Ananta Garments Ltd

Ananta Sportswear Ltd

22 March 2014

Observations

Tested Ground Floor Column

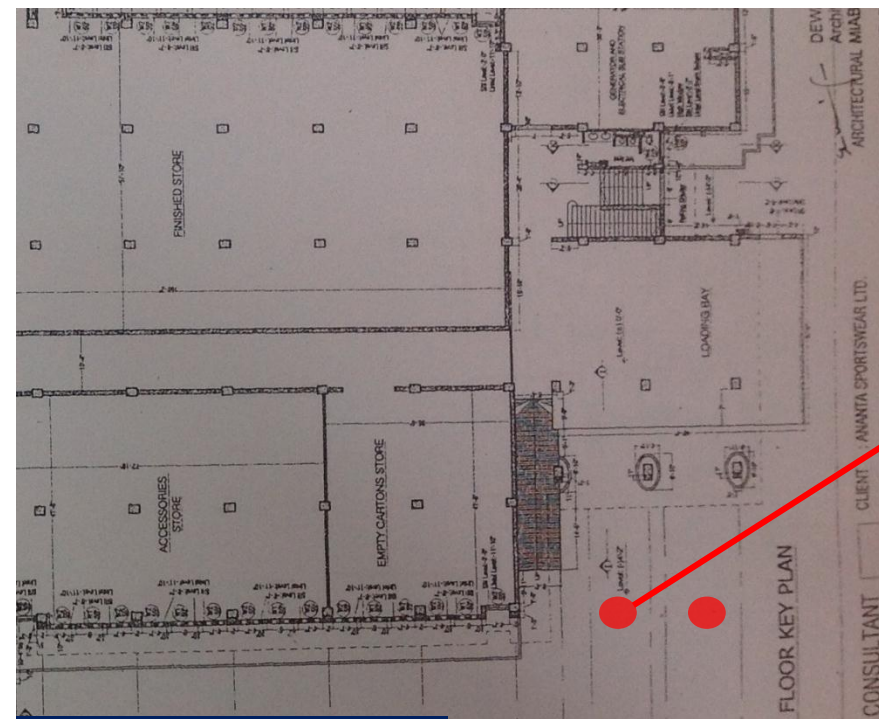
Columns appear to be stressed in excess of normal design limits – Building Engineer to verify concrete stresses and in-situ concrete strength

Cursory calculations indicate that the working stress of columns at Ground Floor level are at a high level.

Building Engineer to check that columns have been designed to accommodate loads.

Column Impact Loading

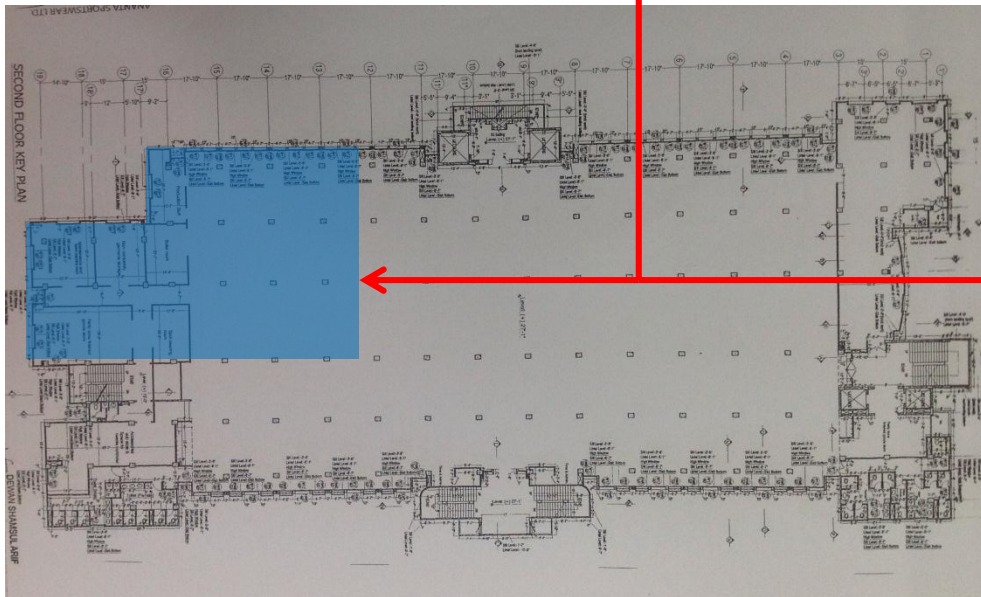
The columns at the delivery entrance to the Building are at risk of being accidentally struck by a vehicle. More substantial Column protection barriers need to be provided

2 no. columns at the delivery entrance to the Building are at risk of being accidentally struck by a vehicle.

Building Engineer to check that the columns have been adequately designed for impact loading, and to ensure protection currently provided for impact loading is adequate.

1st & 2nd Floor Storage Area

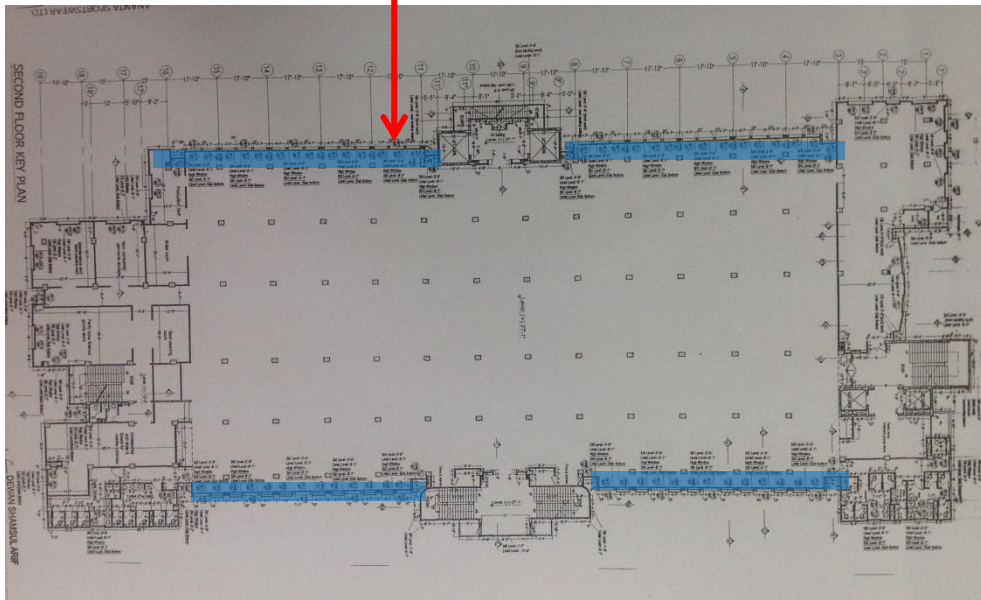
Design Check required for the storage areas as indicated to confirm the capacity of the floor structure

The Storage area to the Second Floor includes distributed loading due to stacking of boxed garments and point loading due to a hanging frame. The Storage area to the First Floor , directly below, includes loading hung from Second Floor slab.

Building Engineer to check that the floor structure has been adequately designed to carry these loads.

View of Façade at 1st Floor

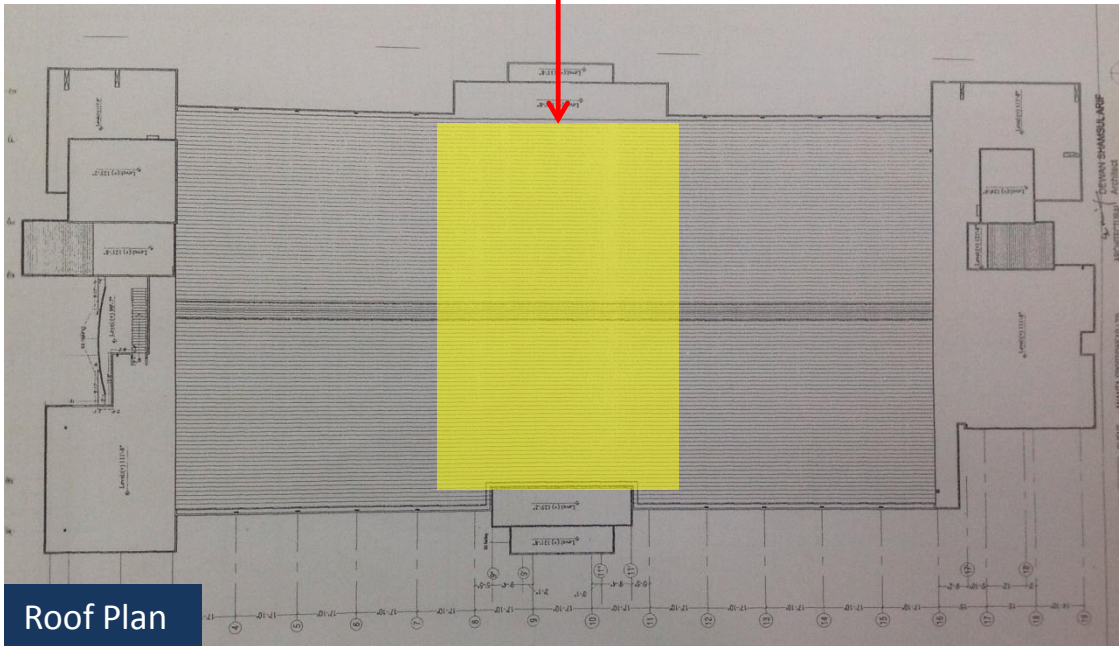
Design check required for the floor cantilevers at the suspended floor levels to confirm their load capacity to support floor and façade loading

There is a slab cantilever to the North and South elevations of the Building above First Floor level.

Building Engineer to check that all the floor cantilevers at the suspended floor levels have the capacity to support the floor and façade loading.

Roof Plan

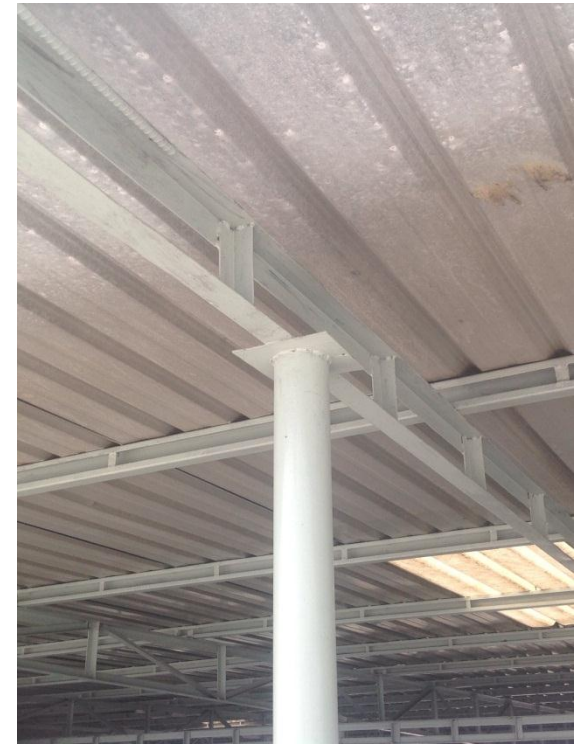
Design Check required for the light steel roof structures as indicated.

Capacity of Lightweight structure at Roof level to resist lateral loading (wind) to be checked.
All connections to be included in this check.

Cracking to 8th Floor Washroom

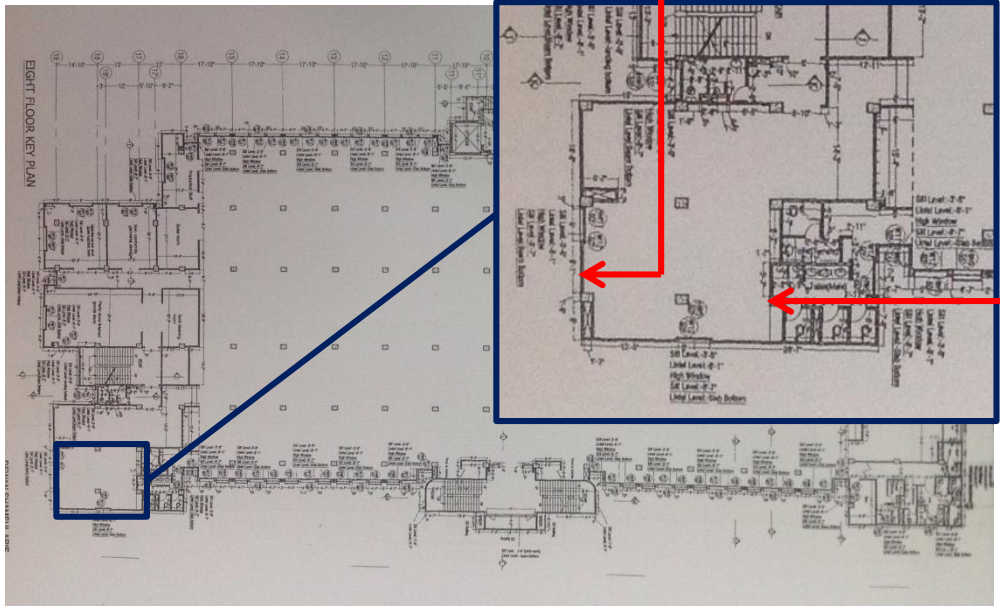
**Building Engineer to investigate the cause
of the local wall cracking at 8th floor level
as indicated**

Cracking to walls at 8th Floor level North-East corner.
Building Engineer to investigate.
